**SOIL VAPOR EXTRACTION (SVE)
FINAL REMEDY CONSENT DECREE
FINAL EXTRACTION AND TREATMENT
SYSTEM DESIGN - POLYGON 84**

**PHOENIX-GOODYEAR AIRPORT (SOUTH)
SUPERFUND SITE, GOODYEAR, ARIZONA**

Subject: Response to U.S. EPA Comments
SVE Final Design-Polygon 84
Phoenix-Goodyear Airport Site
Goodyear, Arizona

RESPONSE TO U.S.EPA COMMENTS

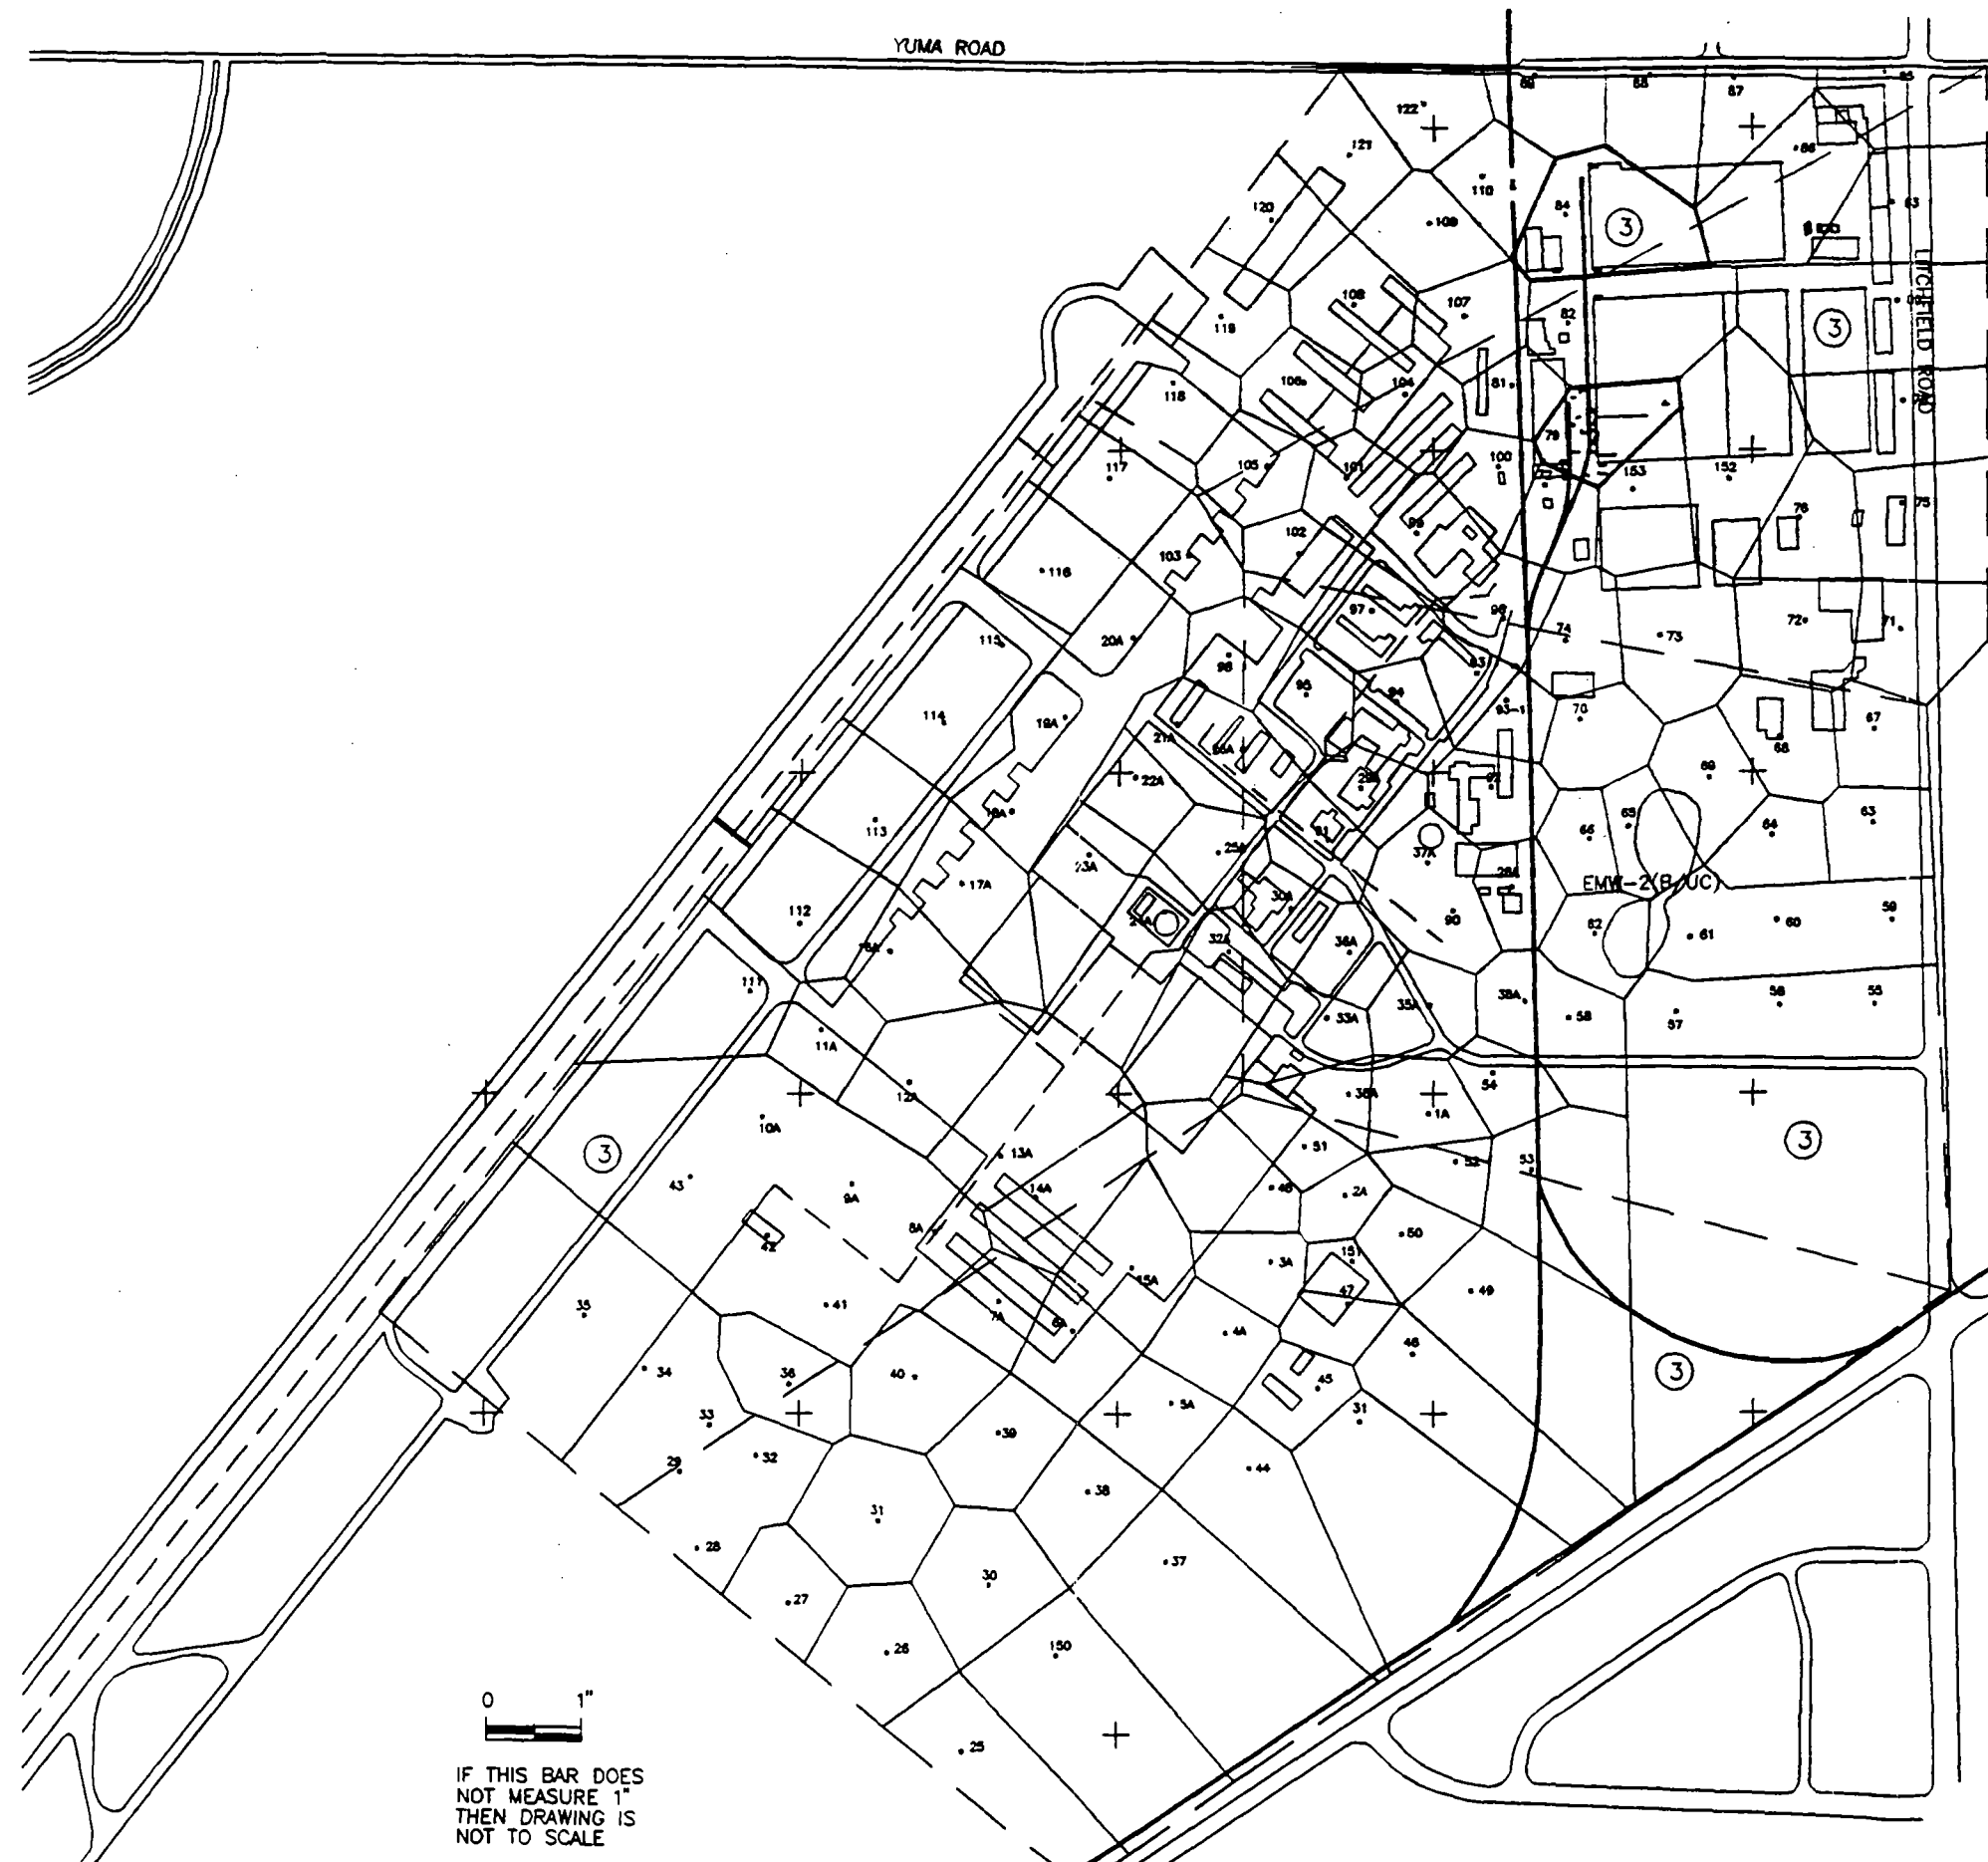
Specific Comment 3-Drawing 84-C-1, Radius of Influence

The 150-foot influence radius was selected conservatively based on Polygon 79 operational data. During start-up and operation at normal flow rates (100-120 scfm), the observed influence, defined as 0.25 to 0.5 inches of water vacuum net of ambient vadose zone pressures was in excess of 184 feet. Using this drawdown data, the Polygon 84 treatment coverage "gaps" are be eliminated, thus not requiring an additional extraction well. The O&M manual will be modified to operate the wells to ensure the appropriate radius of influence to gain Polygon 84 coverage.

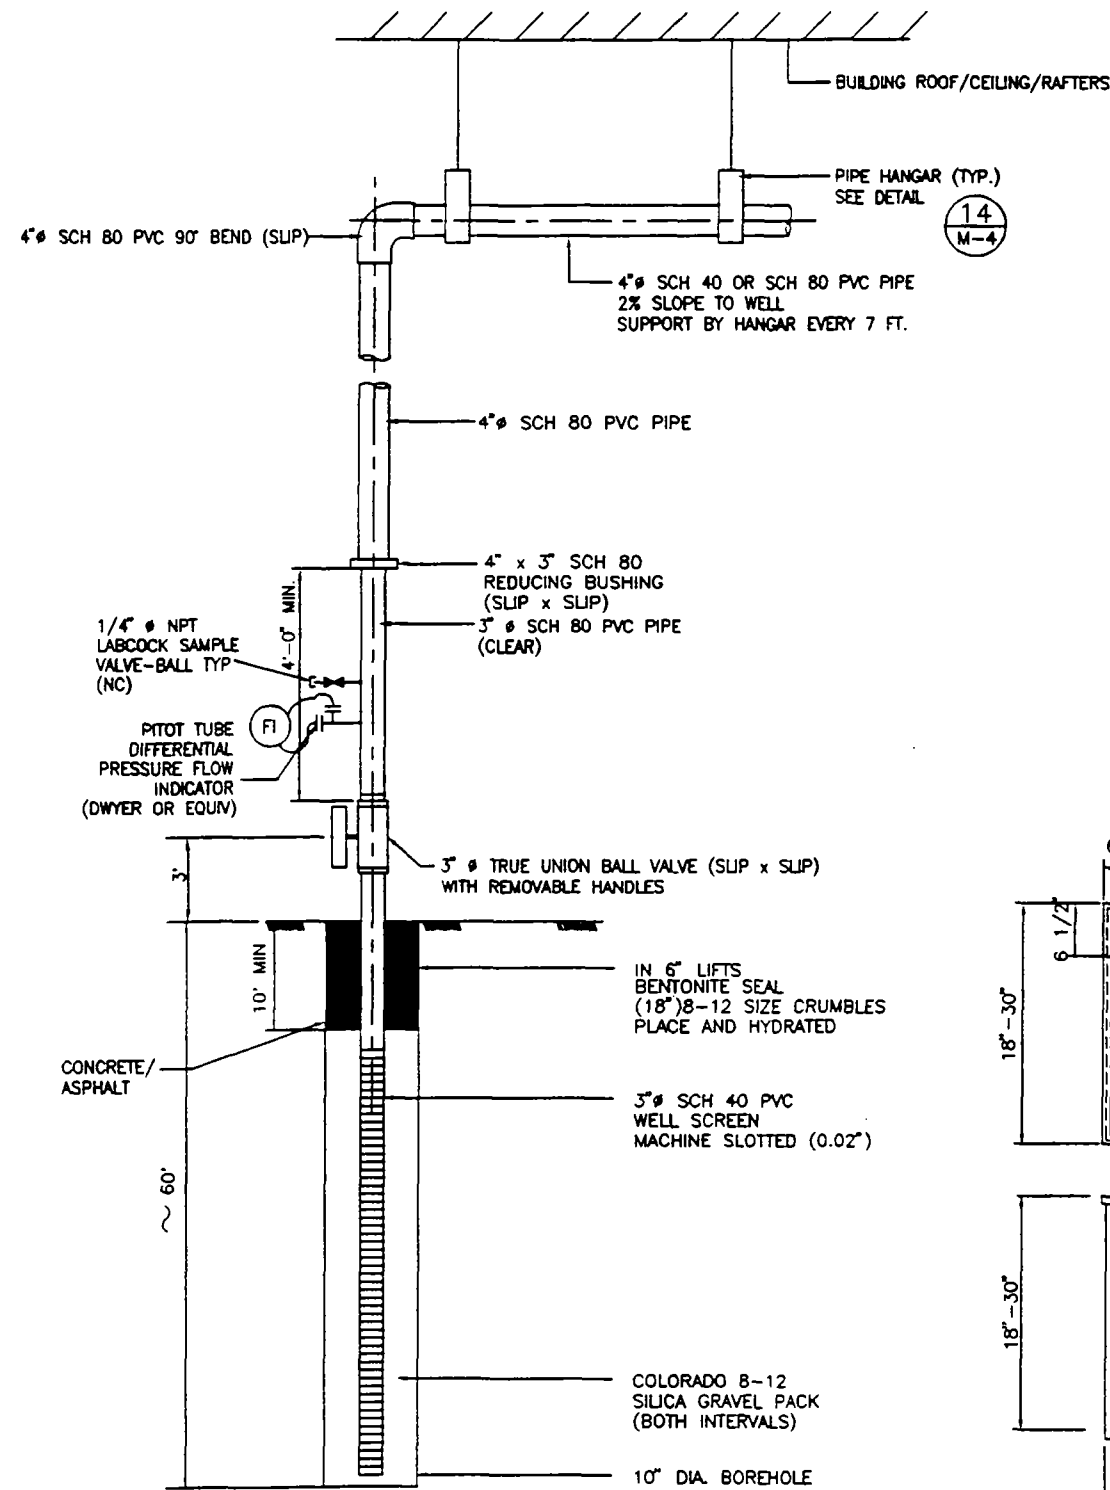
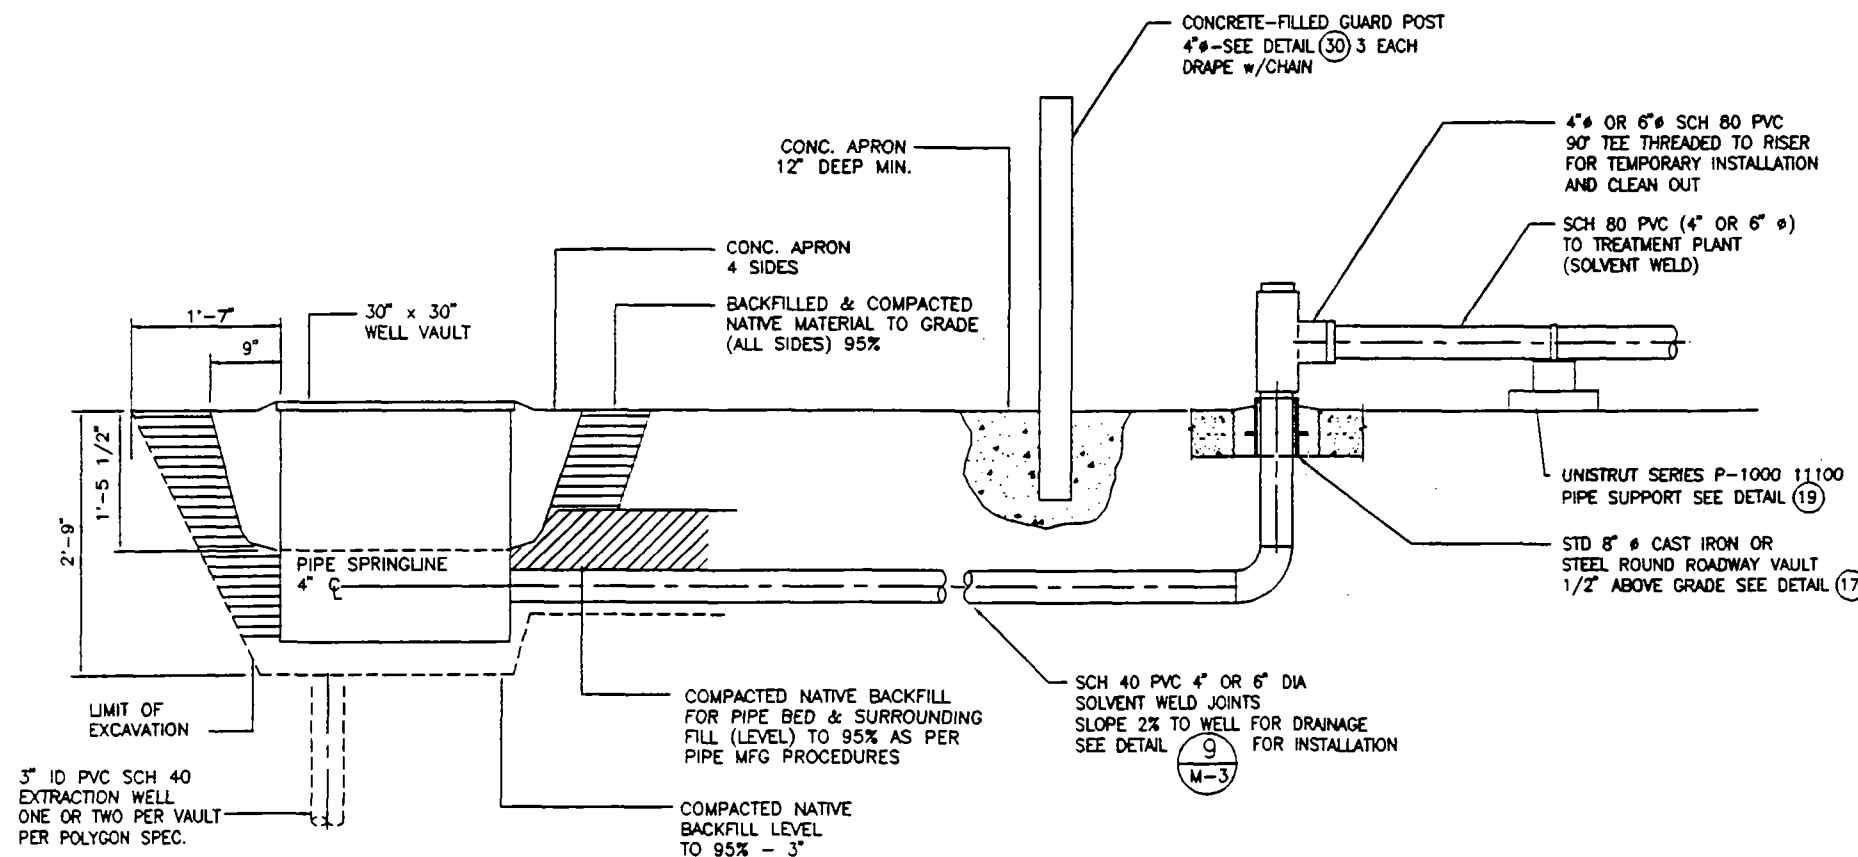
Specific Comment 3-Page 23-Pipe Schedule

Comment noted. Drawings 84-M-4 and 84-M-9 have been modified accordingly to reflect the correct pipe schedule.

DRAWING NO:
84-M-7
SHEET: 10
of 18 SHEETS

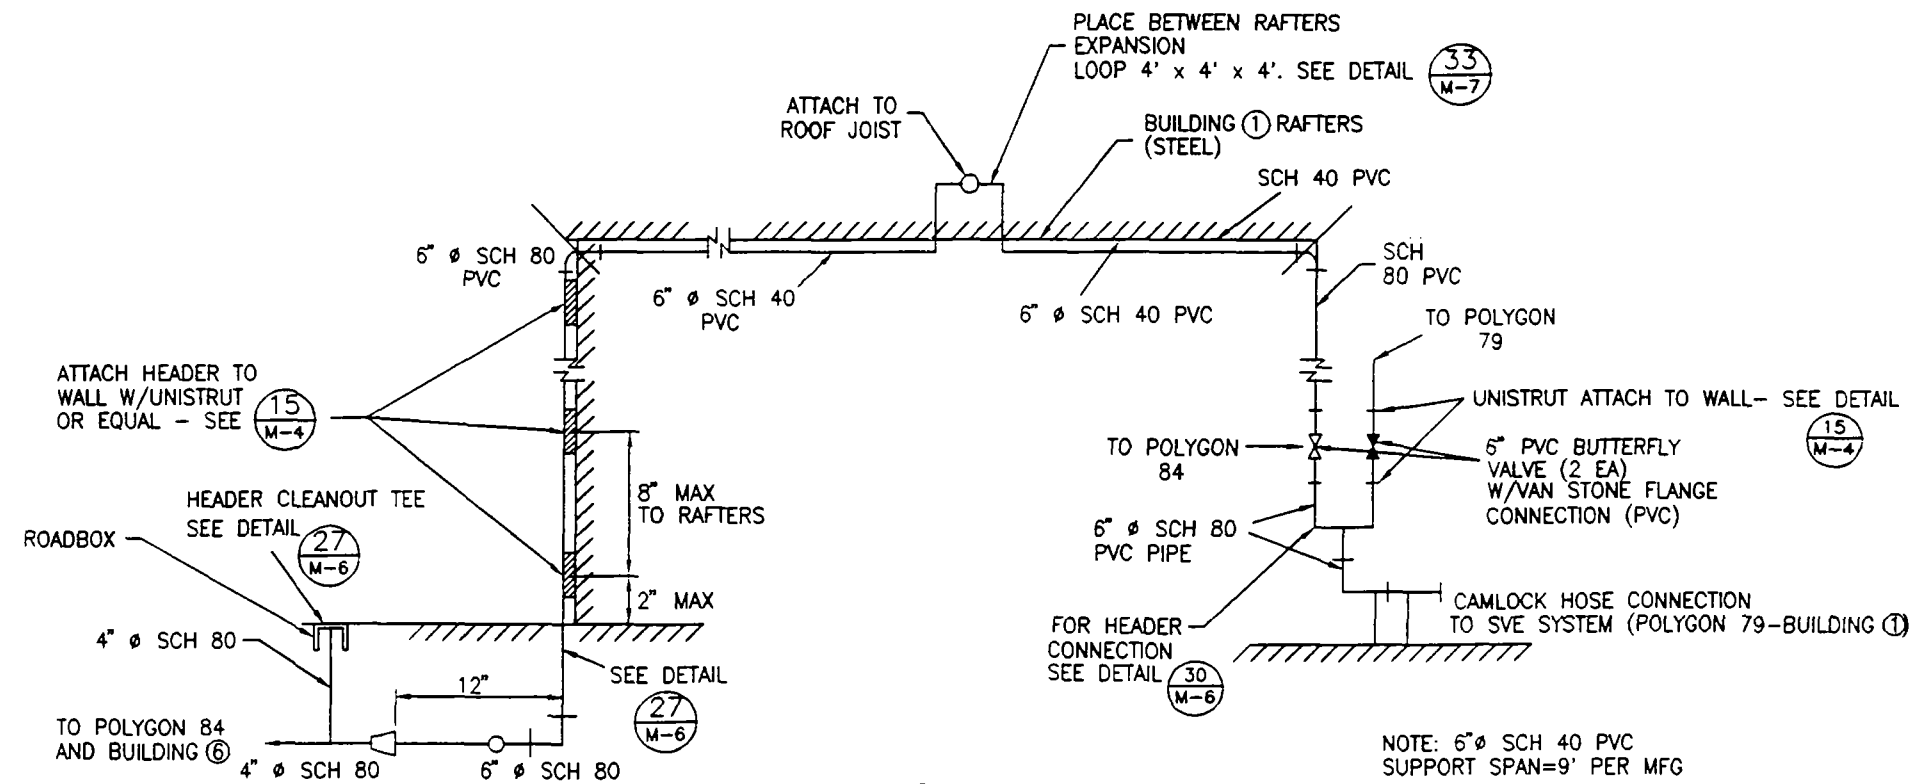
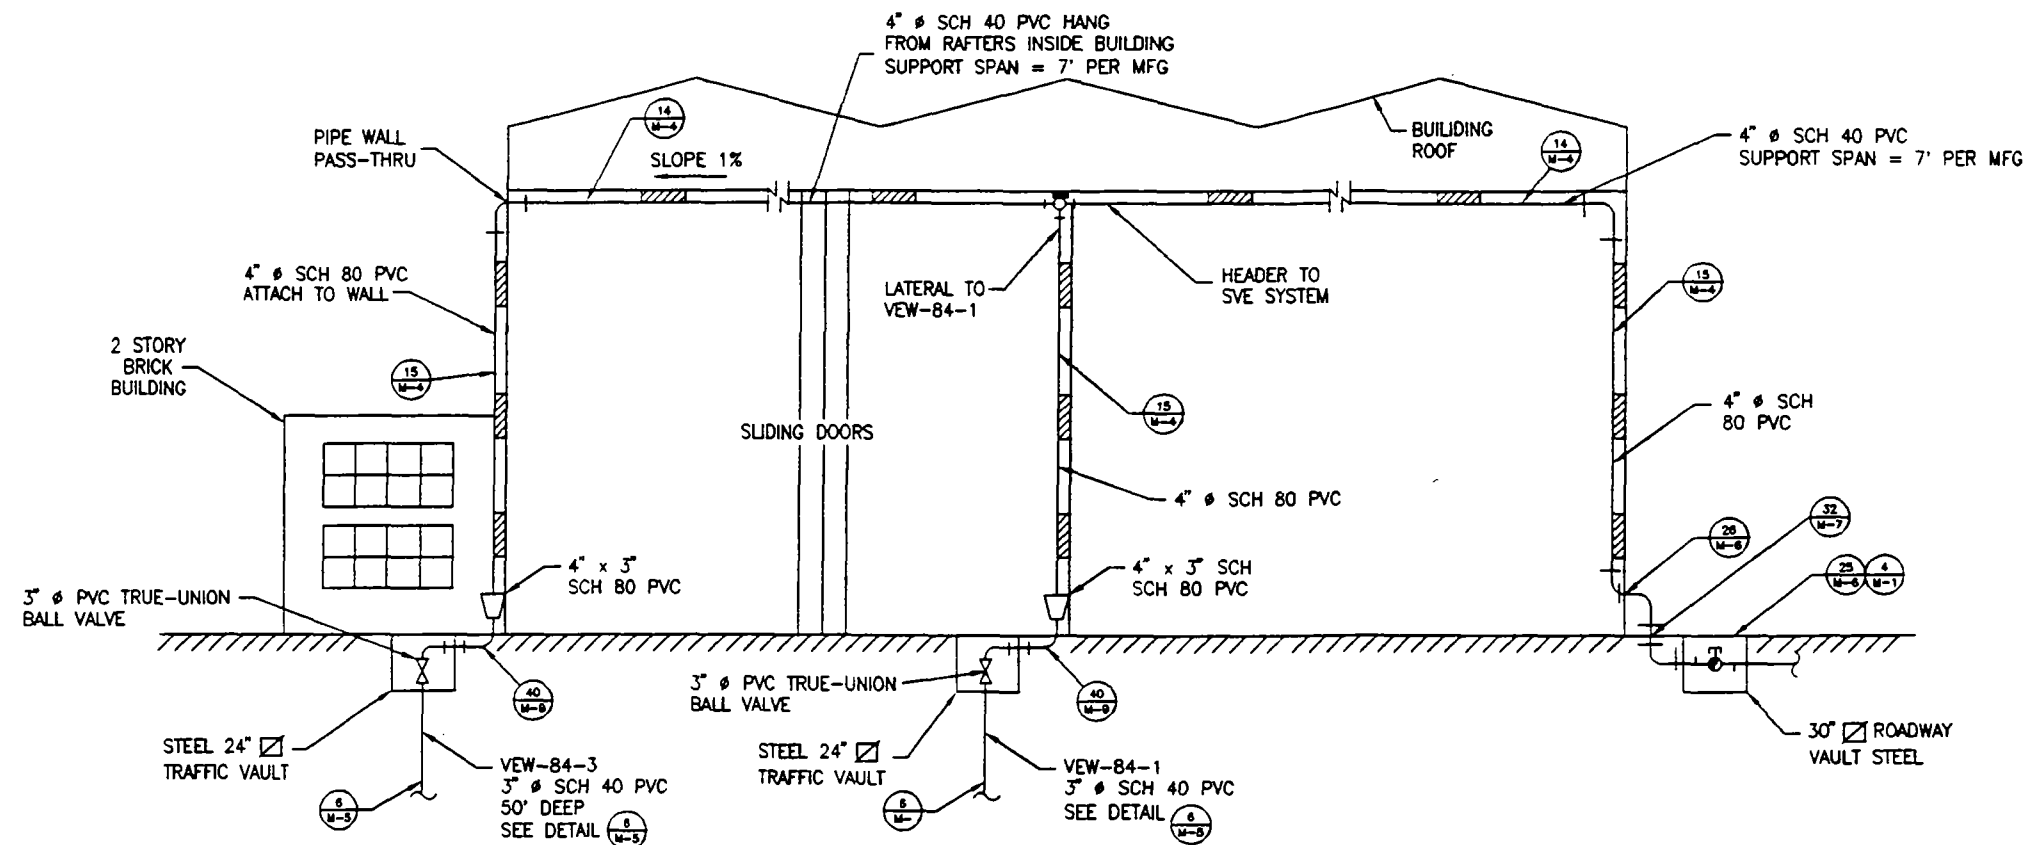
Specific Comment 7-Drawing 84-M-7 Reference

Comment noted. Detail 31 reference has been corrected.
